TOWN OF COTTAGE GROVE
PLAN COMMISSION MINUTES
MAY 27, 2026

To: Town of Cottage Grove Plan Commission
FROM: Mark Roffers, Town Planner
Cc: Kim Banigan, Town Clerk-Treasurer; Nick Bubolz, Town Engineer
DATE: May 18, 2026
RE: Element Lawn and Snow, Conditional Use Permit and Design Review (Lot 4, Swalheim Business Park)

Subject: Element Lawn and Snow Construction Plan Review

To: Town of Cottage Plan Commission
FROM: Mark Roffers, Town Planner
Cc: Kim Banigan, Town Clerk-Treasurer; Nick Bubolz, Town Engineer
DATE: May 19, 2026
RE: Rezoning Request to Facilitate a Prospective Subdivision Plat Along Wittewood Lane

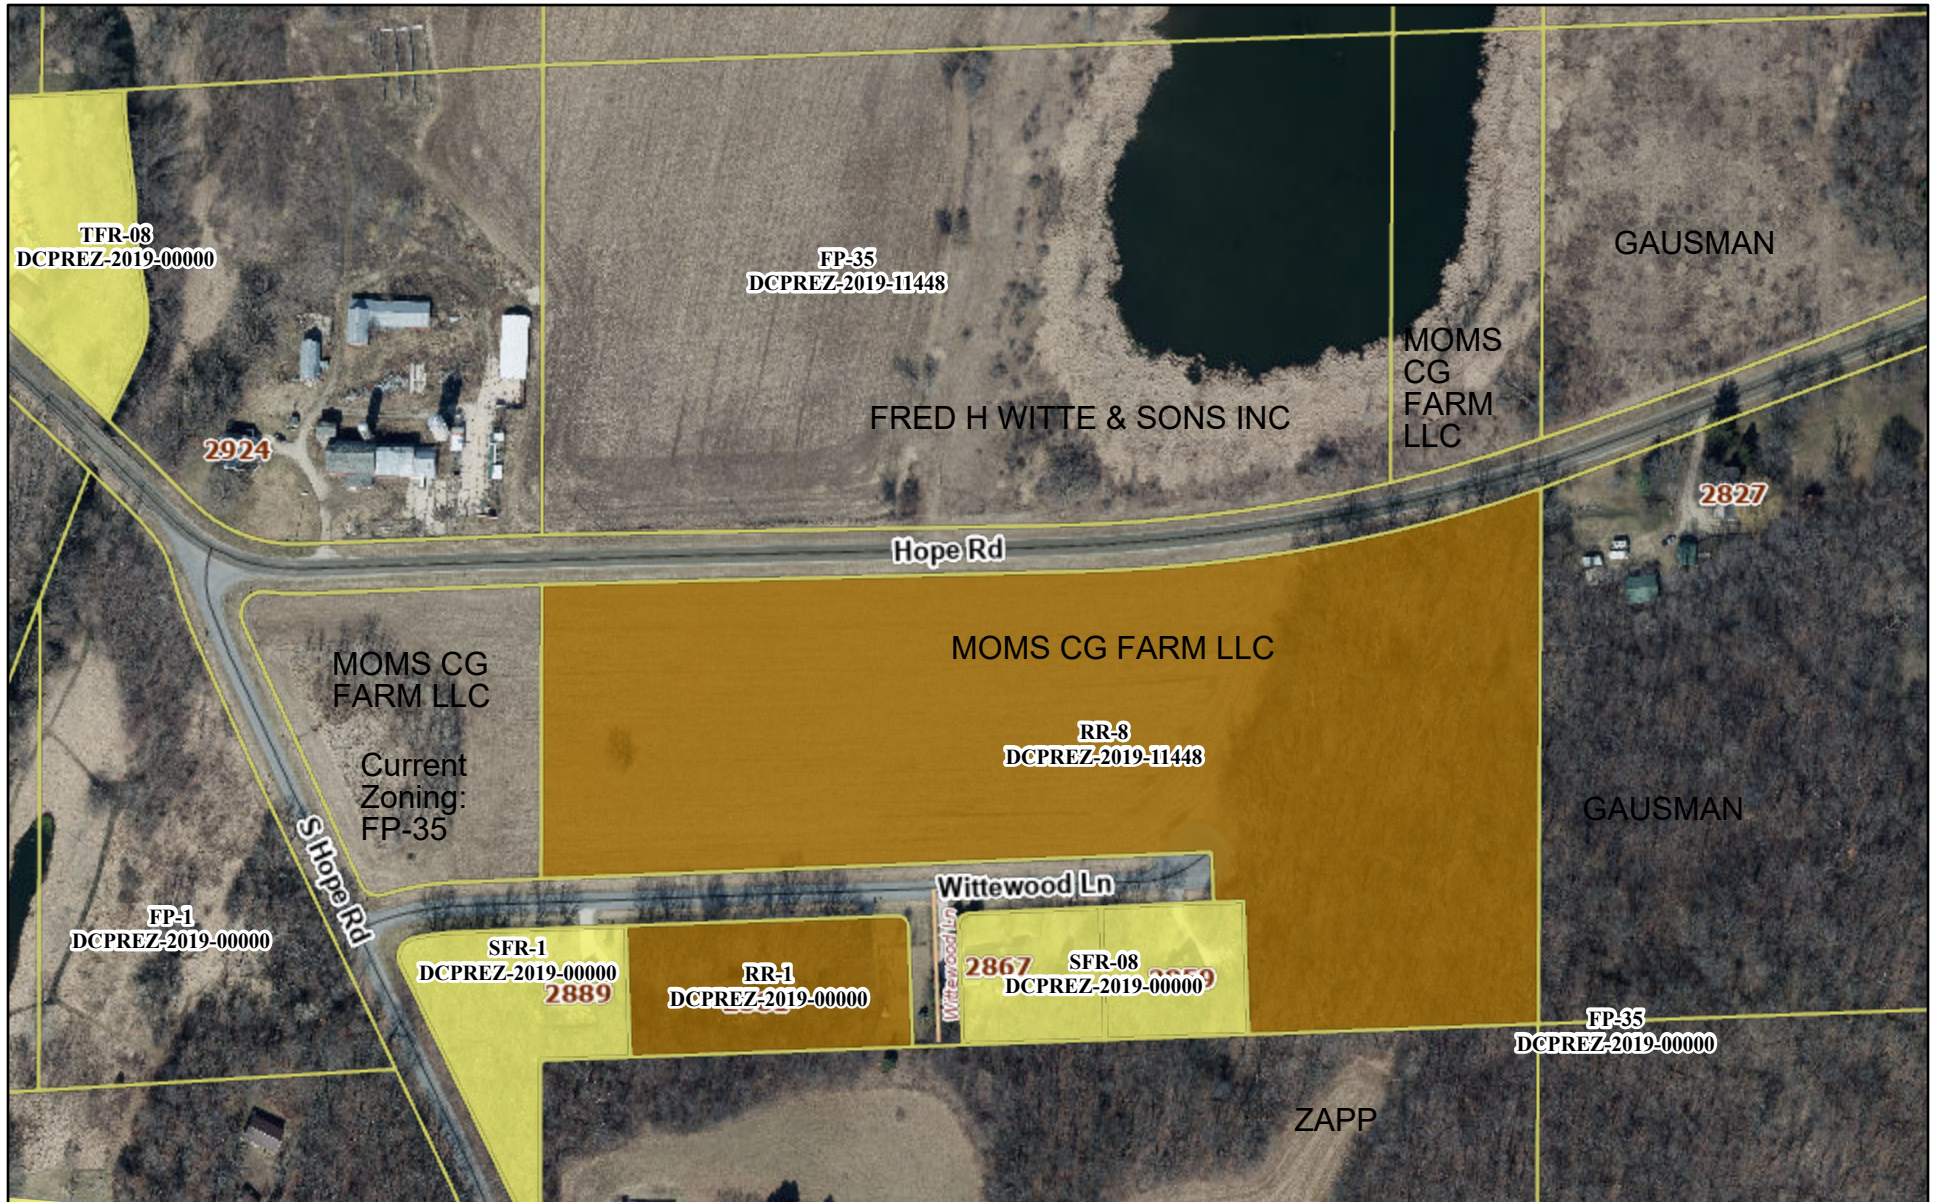
Representatives of Moms CG Farm LLC have applied to rezone approximately 17.7 acres between Hope Road and Wittewood Lane to the SFR-08 Single-Family Residential district to facilitate a 10-lot residential subdivision. Following rezoning, preliminary and final subdivision platting, civil and stormwater engineering, and a development agreement would be required.

Following interactions with the Town Engineer and County Zoning staff, it is my advice that the Town Plan Commission postpone action on this rezoning application until outstanding issues underlined below have been resolved.

Natural Features and Indicators

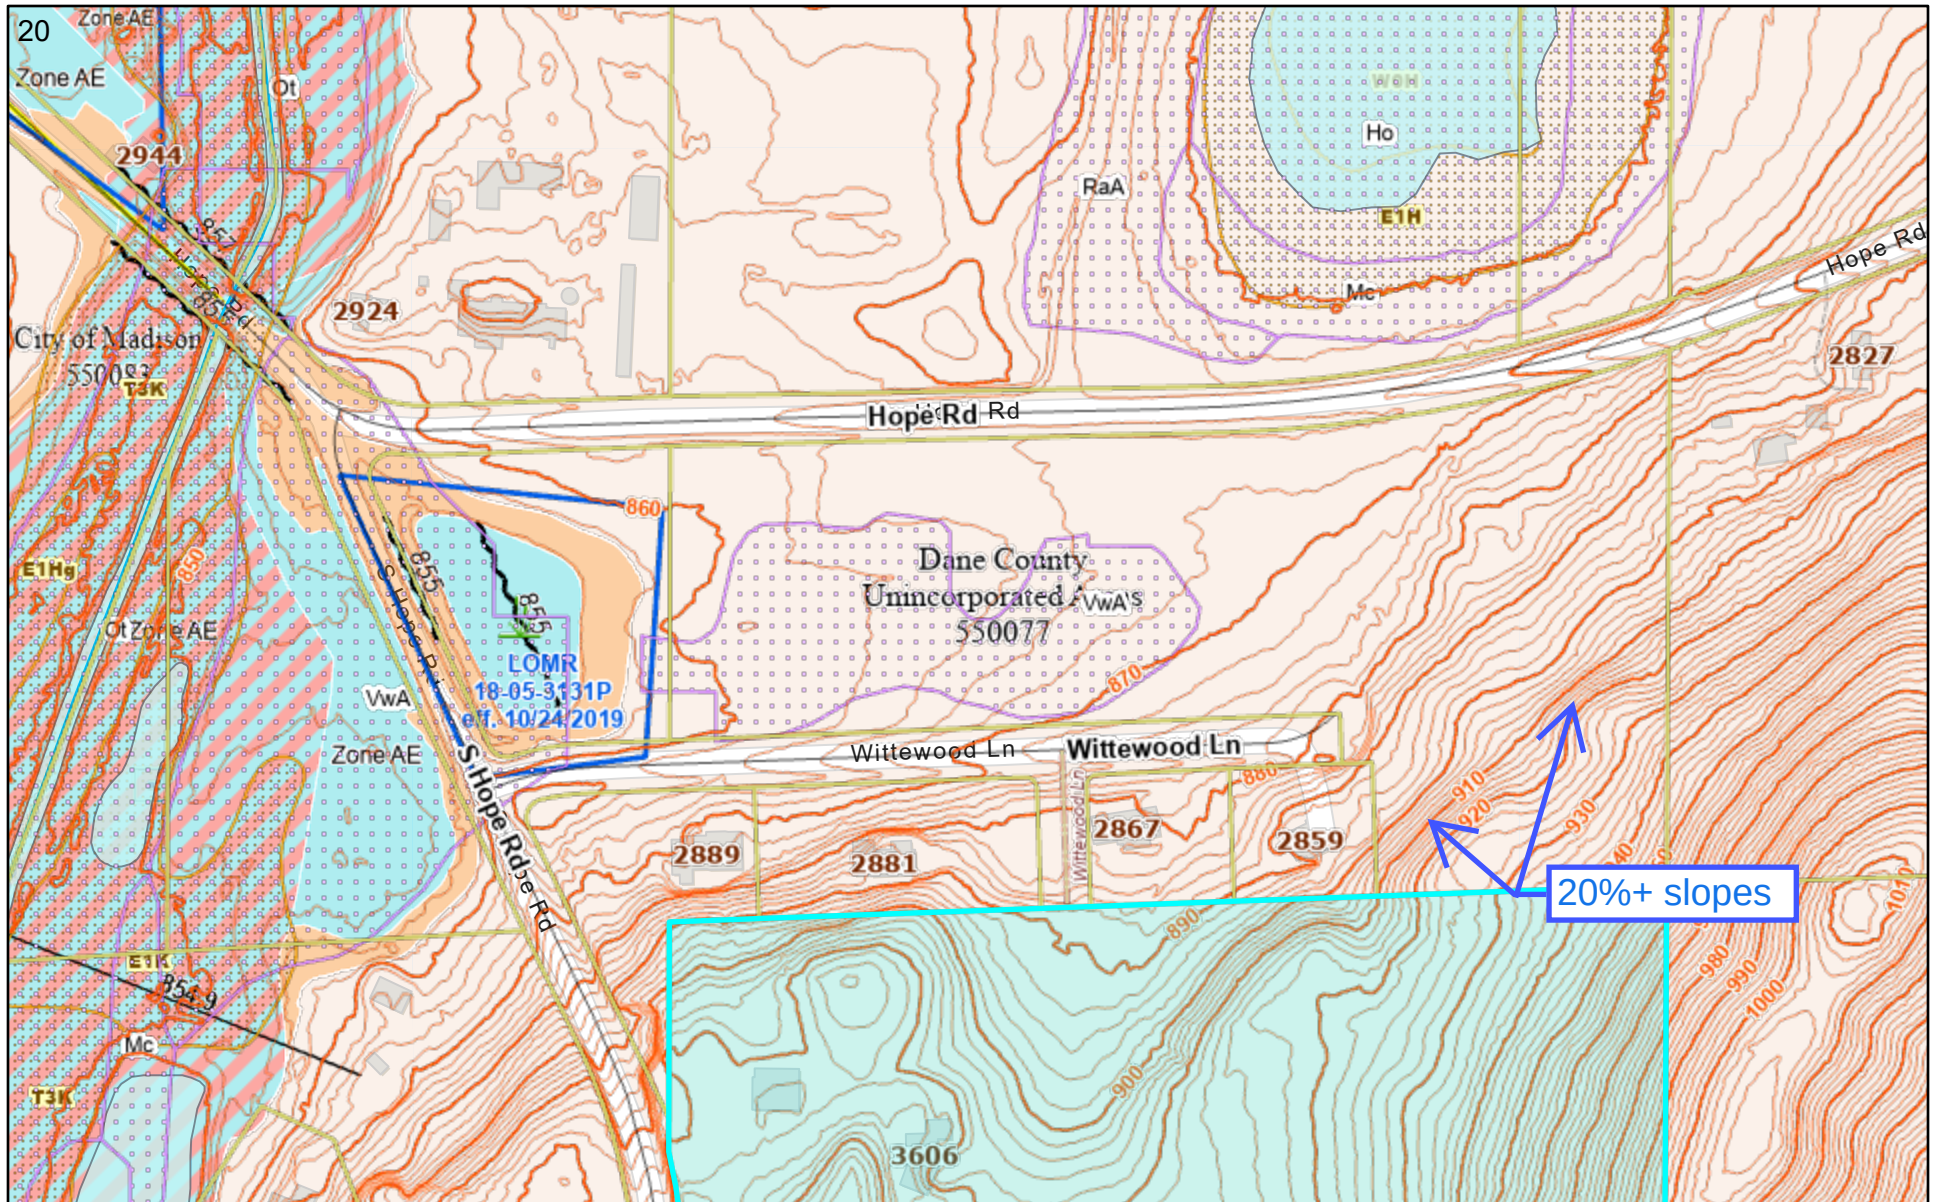
6. The subject site is affected by a few natural limitations, as suggested by the attached Natural Features and Indicators map, and described as follows:

- a. WisDNR indicates dotted areas on the attached map as having wetland indicators, which signals the need for a field wetland delineation to verify. In 2020, Heartland Ecological Group completed a wetland report for the applicants that delineated one 0.86-acre wetland within parcel 0711-301-8000-0, classified as shallow marsh and shrub carr within a constructed stormwater basin. Heartland’s report suggested that this wetland *may* be subject to state and/or federal regulation, and that the report be submitted to the associated agencies for final jurisdictional review and concurrence. It is unclear to me whether the wetland report was submitted and whether the 2020 delineation has expired. Wetland delineations are typically valid for five years.

- b. FEMA designates the aqua shaded areas on the attached Natural Features and Indicators map as 100-year (1%) floodplain (regulated by zoning), with orange areas beyond as 500-year (0.2%) floodplain. While 500-year floodplain is not subject to

- zoning regulations, there might be limitations on using such any floodplain area for stormwater management. The applicants are advised to consult with the Dane County Land and Water Conservation Department on possible floodplain/stormwater limitations, even if this area was authorized for stormwater management previously.

- c. There are areas of 20%+ slopes in the southeast corner of the subject site (proposed Lot 10 area). The Town through its Plan advises new development be directed away from 20%+ slopes. The Town's driveway ordinance sets a maximum 12% driveway slope. The applicants should suggest an approach to this challenge. Perhaps establishing a buildable area on the plat that is below (west of) the steep sloped area, and a restriction on disturbance in covenants, are solutions.
